Product Change Notification

PCN No: MSS-23-1201-CCB-1101

Update to SI531x/2x/6x Jitter Attenuating Clock Recommended Crystals List

Si531x/2x/6x Jitter Attenuating Clock Recommended Crystals List

Figure 1. 114.285 MHz 3OT R1, C0 Requirement

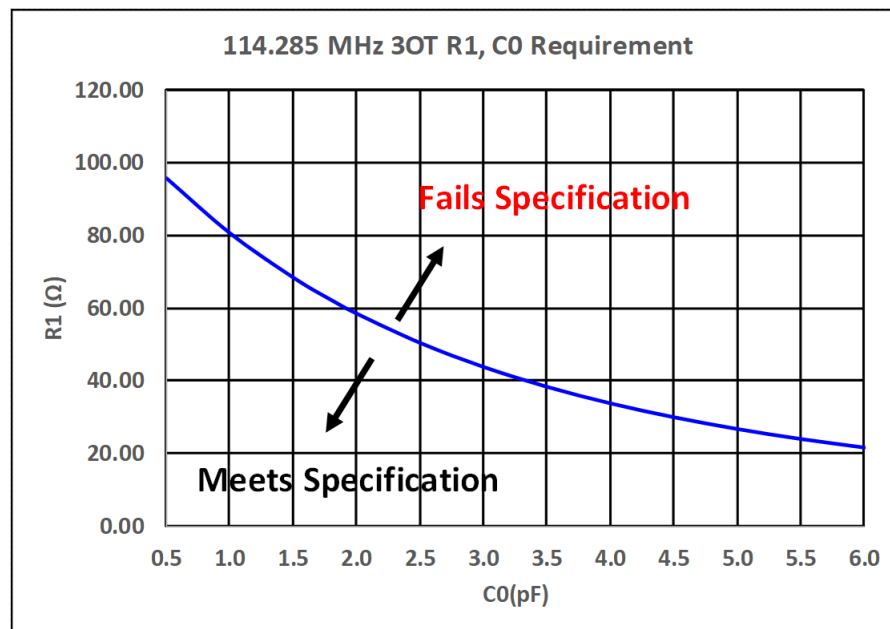
Added 114.285 MHz 3OT crystal R1, C0 Requirement plot, clarified covered devices and customer guidance.

At the time each recommended 114.285 MHz third OT crystal was selected they met the specification for crystal motional resistance R1 versus shunt capacitance C0 plotted below. (Note that R1 may be referred to as ESR by some vendors on their data sheets.)

Crystal manufacturers reserve the right to change their crystal specifications at any time independently of this document. It is ultimately the responsibility of the crystal user to verify any crystal selected from this list still meets the specifications and requirements indicated in both the Skyworks device data sheet, as well as this Recommended Crystal document, before committing to use the selected crystal.
